PLANNING COMMISSION STAFF REPORT

Case: Site Plan Design Review (SPDR) 2021-39

Project: New Two-Story Accessory Dwelling Unit

Location: 1017 Oak Avenue

A-1

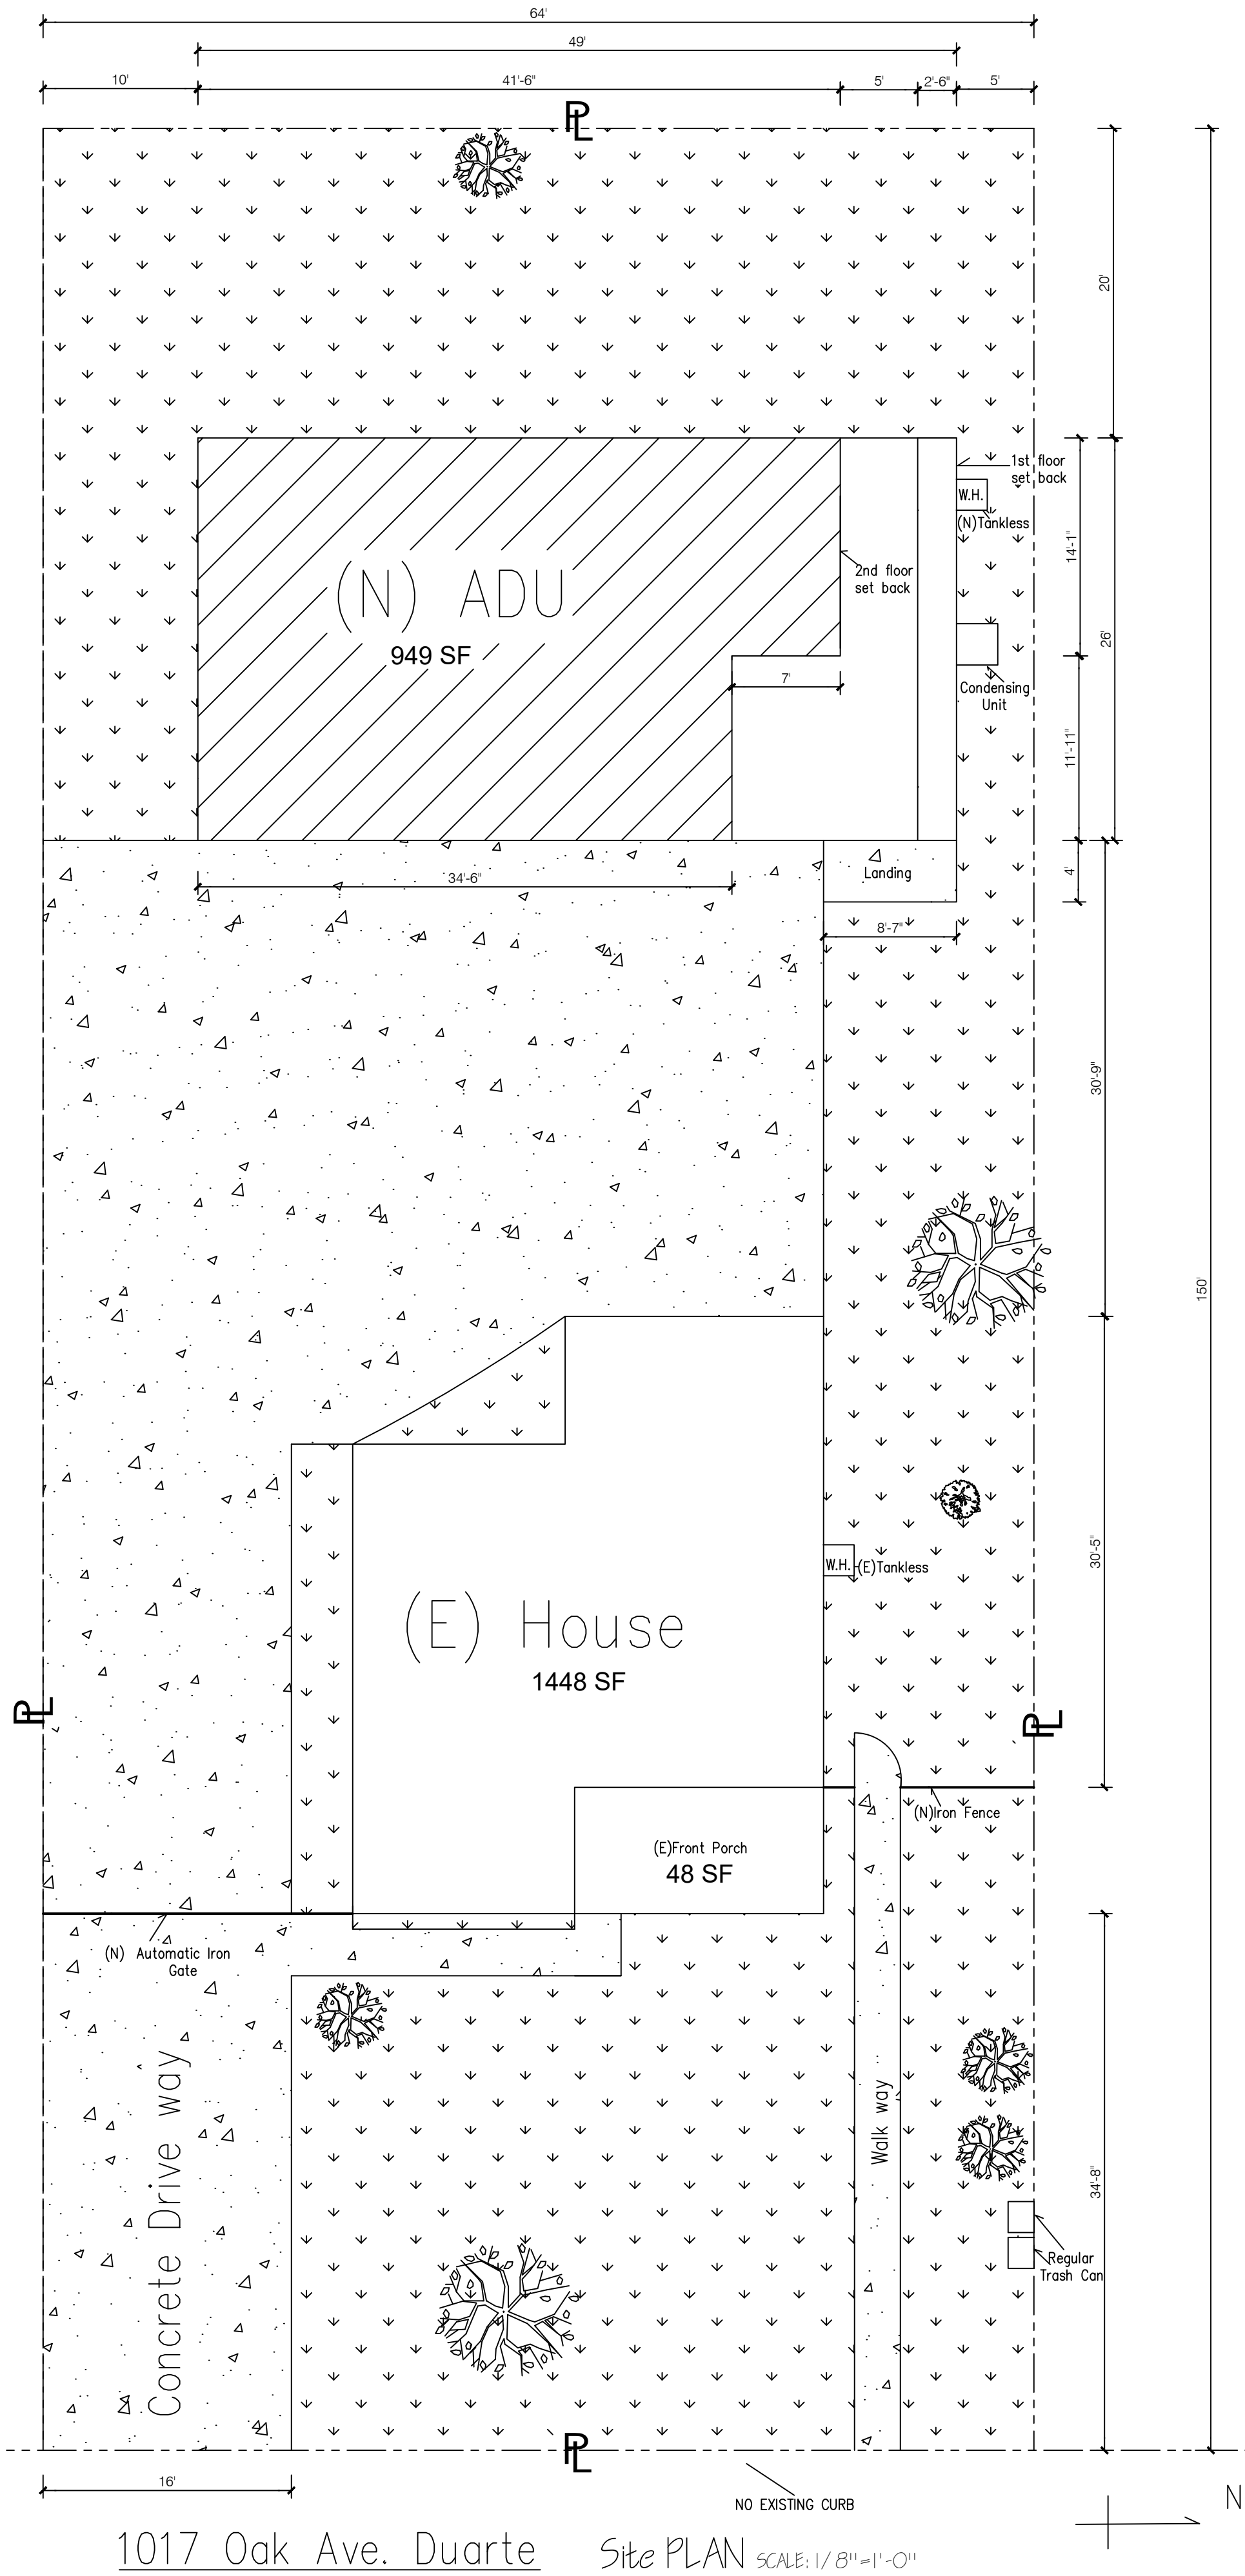
The required rear setback for a two-story structure in the R-2 zone is 20'. The applicant initially proposed a five-foot (5') rear yard setback. This has since been changed to 20'. Several mature avocado trees are located near the main house. The trees are not protected under the City's tree protection and preservation ordinance; however, the owners have indicated they intend to keep them. The applicant has also complied with the side yard setbacks for the structure, including the multi-story setback required per Section 19.10.040 of the Duarte Development Code.

7. All new driveway is required from the public street to the area in front of the garage, as shown on approved plans. All driveway areas shall be constructed of Portland cement concrete at least three inches thick.

East Elevation Scale: 1/4" = 1'-0"

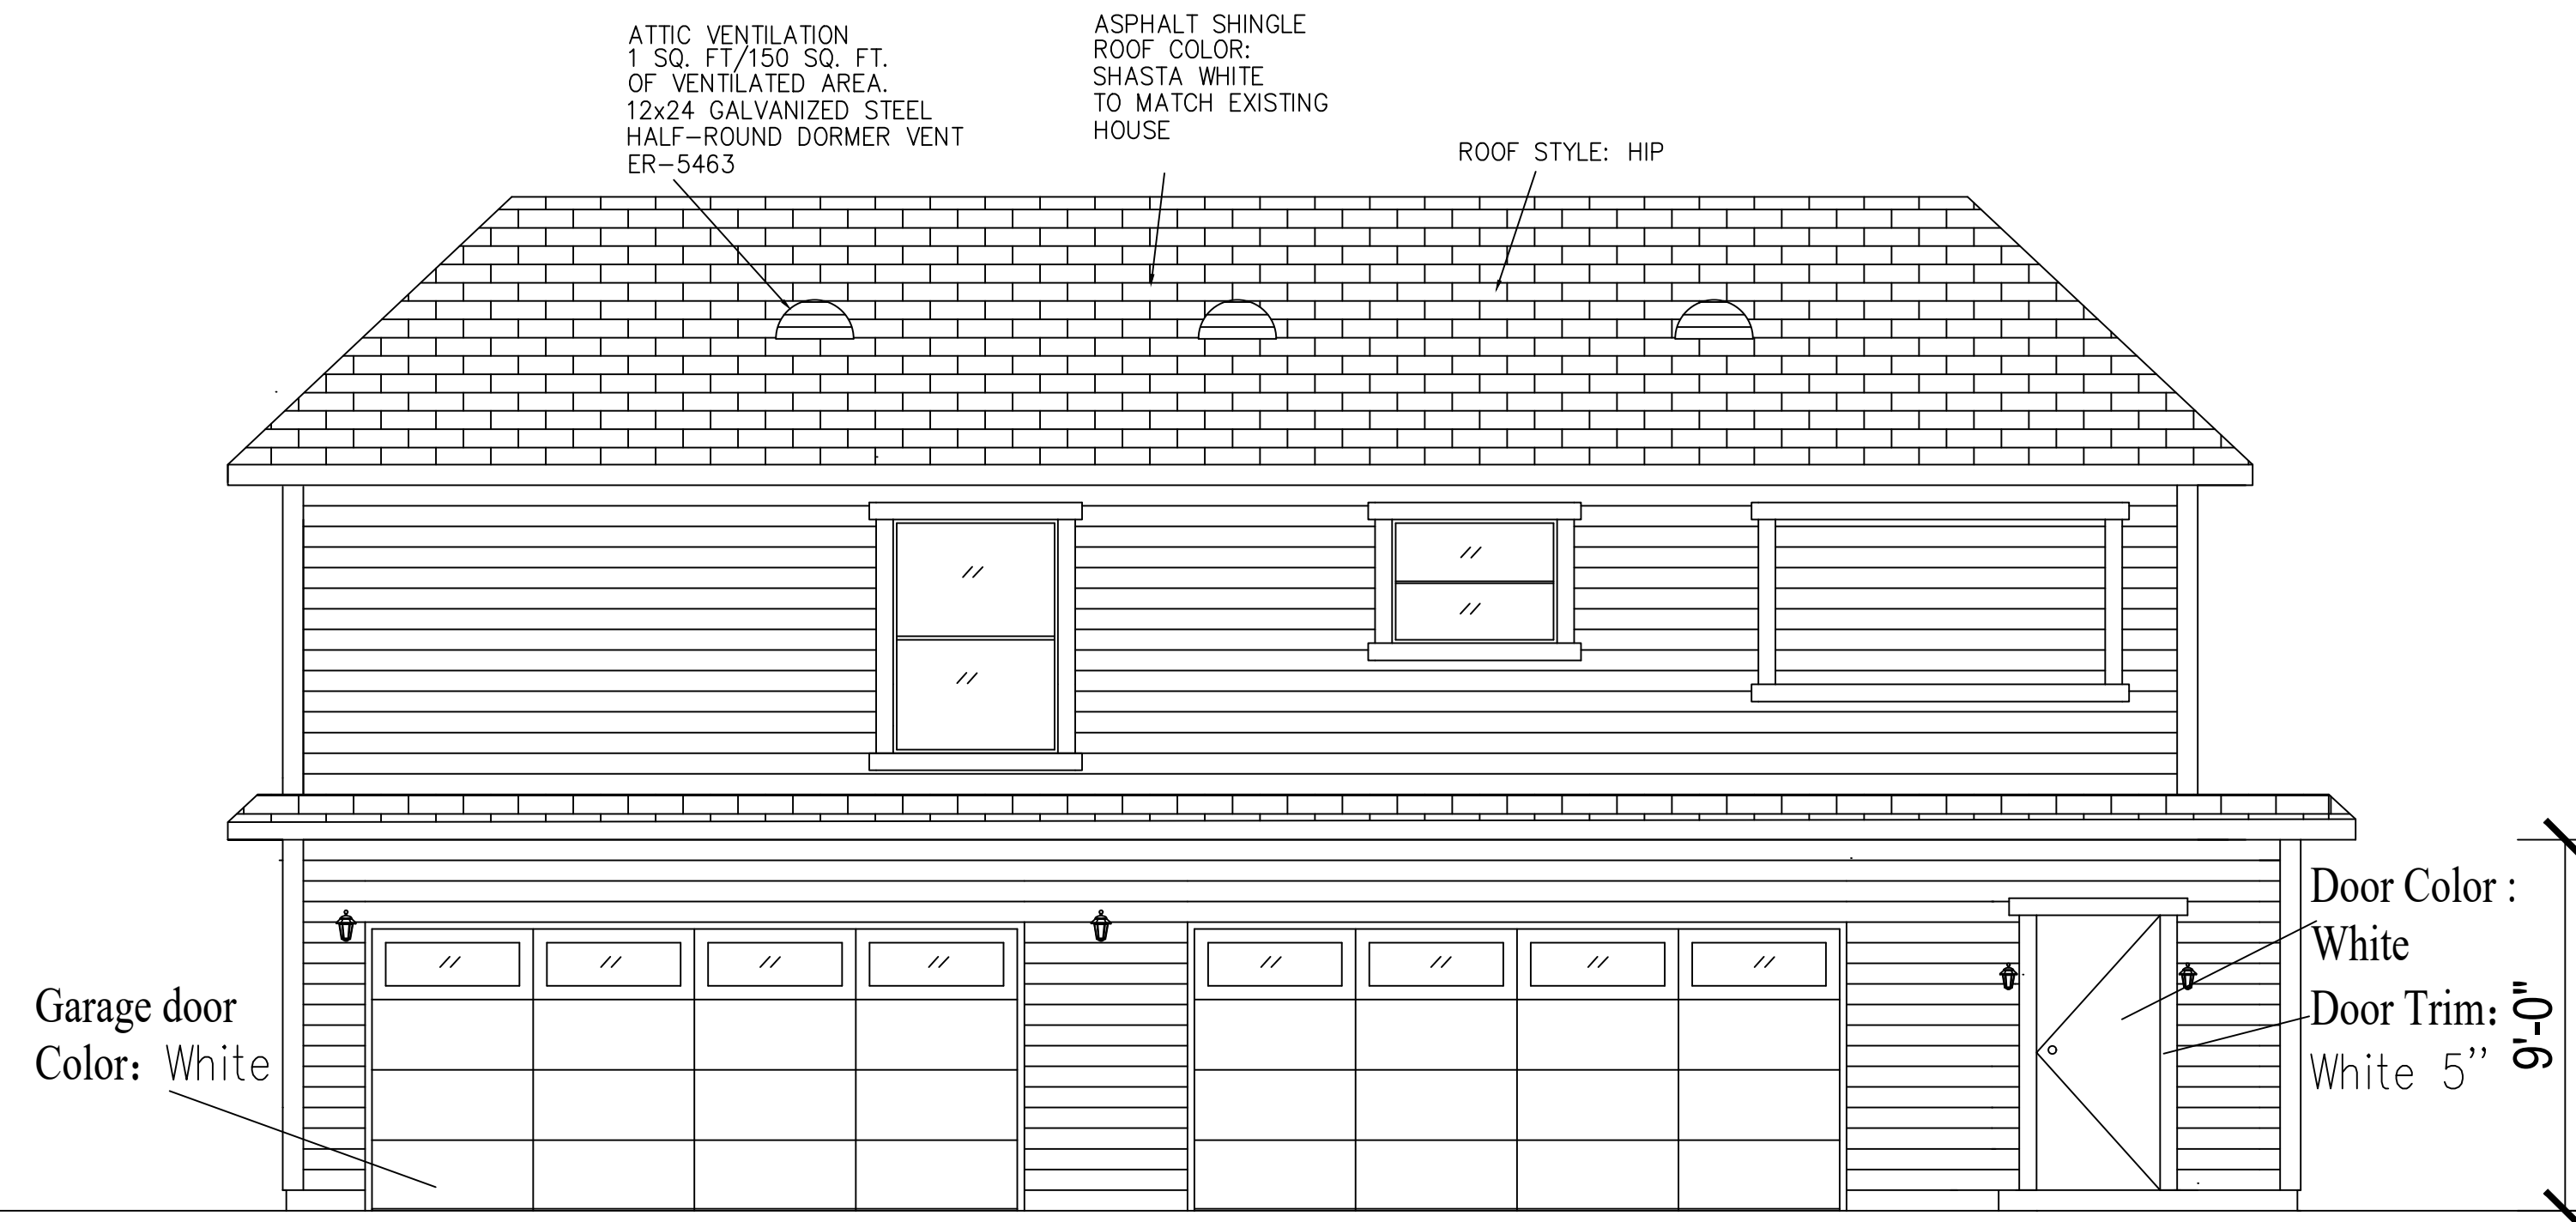
- Landscaping. *The project does not propose or require any new property landscape or irrigation.*
- Lighting. *Four (4) wall-mounted exterior light fixtures are proposed to be installed on the new front (east) elevation of the ADU/Garage. Conditions have been added to ensure light glare does not affect adjacent properties.*

5. Any new exterior lighting shall comply with Chapter 19.50.070 of the Duarte Development Code and requires approval from the Planning Division prior to installation and/or issuance of building permits. Details (cut-section drawings, manufacture brochure, etc.) shall be provided to the Planning Division for review. All exterior light fixtures proposed to be installed on the ADU and the detached garage shall be full cut-off and downcast.
